# UNITED STATES PATENT AND TRADEMARK OFFICE

10/696,236

<b>Office Action Summary</b>	<b>Application No.</b> 10/696,236	<b>Applicant(s)</b> CREDELLE, THOMAS LLOYD	
	<b>Examiner</b> SEOKYUN MOON	<b>Art Unit</b> 2629

## DETAILED ACTION

Drawing 1

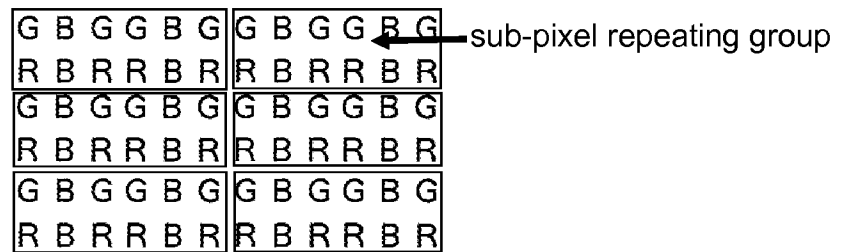
The Applicant argues, "*Applicant respectfully submits that a person skilled in the art cannot reasonably view Mori Fig. 15 as showing an even number of subpixels in the row of the repeating group. The 'One Pixel' of Mori Fig. 15 is a repeating group and it has an odd number of subpixels.*". However, Examiner respectfully submits that none of the limitation of the claims requires Examiner to interpret only one pixel of Mori as the claimed repeating group. Since groups of pixels are repeated in the device of Mori, it would be reasonable to one of ordinary skilled in the art to construe each of the groups of pixels as the claimed repeating group [drawing 1 provided on page 3 of this Office action, which is same as figure 15 of Mori] (As shown below, in the device of Mori, there are a plurality of repeated groups each of which comprises four pixels).

a panel [fig. 4, col. 4 lines 1-2, and drawing 1 provided on page 3 of this Office Action] substantially tessellated by a sub-pixel repeating group comprising differently colored and individually addressable sub-pixels and having an even number of individually addressable sub-pixels in a row [drawing 1], the sub-pixel repeating group further comprising a column of first colored sub-pixels (the two blue sub-pixels arranged in one column of the sub-pixel repeating group as shown on drawing 1), where the color of the first colored subpixels (the two blue sub-pixels arranged in one column of the sub-pixel repeating group as shown on drawing 1) is one to which the human visual system has lower luminance change sensitivity than to other colors of other colored ones of the subpixels in the subpixel repeating group; and

and individually addressable sub-pixels and having an even number of individually addressable sub-pixels in a row [drawing 1], the sub-pixel repeating group further comprising at least one column of blue sub-pixels (the two blue sub-pixels arranged in one column of the sub-pixel repeating group as shown on drawing 1); and the method comprising:

As to **claim 3**, Mori [drawing 1 provided on page 3 of this Office Action] teaches the sub-pixel repeating group substantially comprising red and green sub-pixels interspersed with two columns of blue sub-pixels.

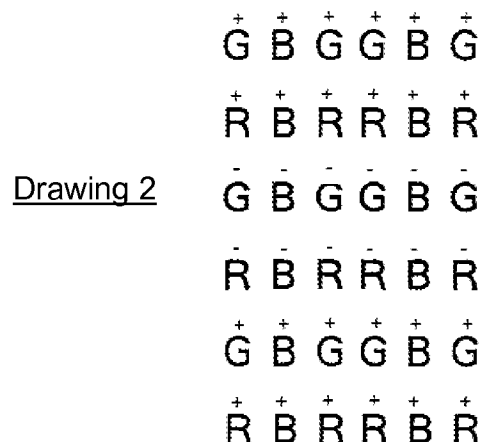
As to **claim 9**, Mori teaches the column of first colored sub-pixels being the column of blue sub-pixels [drawing 2 provided on page 10 of this Office Action].

As to **claim 28**, Mori teaches that the driver circuit sends signals indicating image data having a polarity scheme to the panel such that at least two adjacent subpixels in a row have the same polarity [drawing 2 provided on page 10 of this Office action].

As to **claim 30**, Mori as modified above teaches that the image degradation is caused by same-color subpixels of same polarity occurring successively one after the next [drawing 2 provided on page 10 of this Office action].

Drawing 3

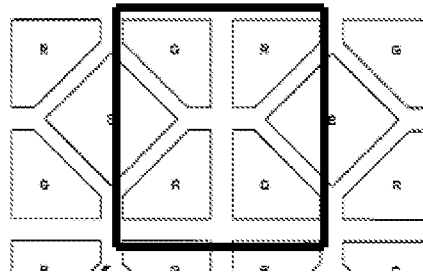
However, Martin [drawing 3 provided below, which is same as figure 2 of Martin] teaches an arrangement of having four sub-pixels (the sub-pixels included in the rectangle drawn with solid lines) having two different colors in a checkerboard pattern so that the two sub-pixels having a same color are not adjacent to each other in a horizontal direction and in a vertical direction.

It would have been obvious to one of ordinary skill in the art at the time of the invention to apply Martin's red and green sub-pixel arrangement in the modified Mori's display, in order to provide an uniform color illumination for a liquid crystal display by placing the four adjacent sub-pixels having two different colors in a pattern such that the two sub-pixels having a same color are not adjacent to each other in a horizontal direction and in a vertical direction.
